**Amendments to the Drawings:**

## REMARKS

FIG. 1

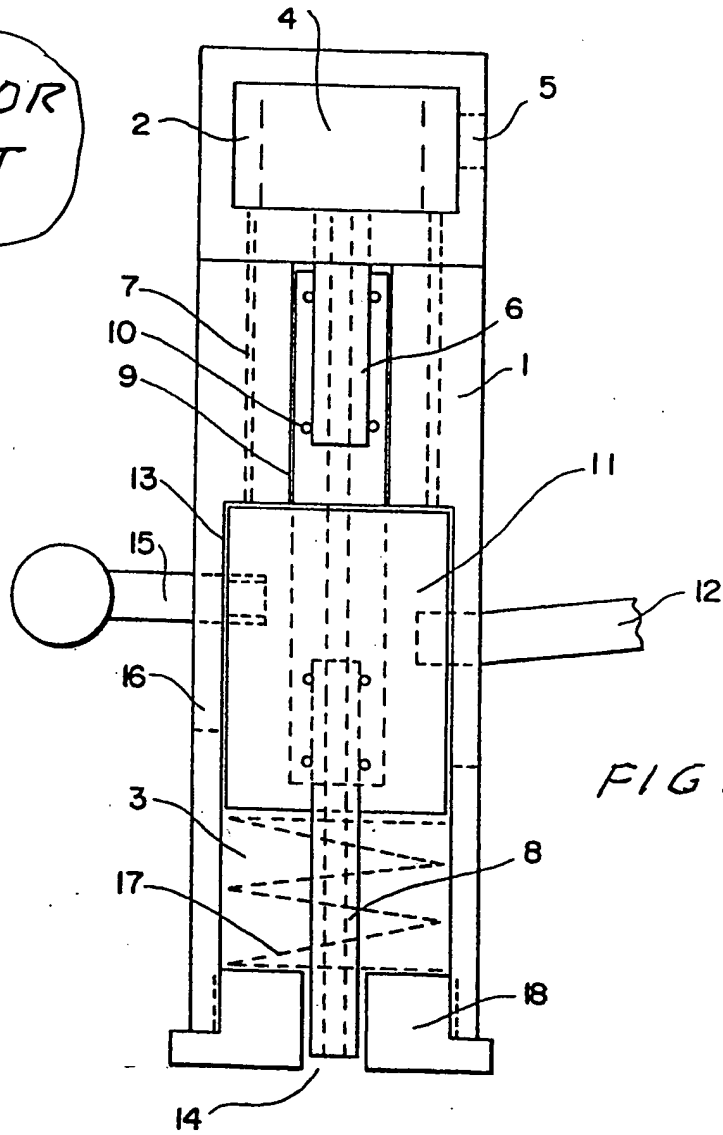
The Examiner in his summary sheet objected to the drawing but did not give his reason for doing so. Applicants suspect that Examiner felt the drawing should be identified as prior art since it is the same as the drawing in Mustonen. Applicants have therefore modified the drawing to indicate that it is a prior art drawing.

The attached drawing sheet replaces the single drawing sheet in the application. The drawing sheet has been amended to show that the drawing is prior art.

PRIOR  
ART
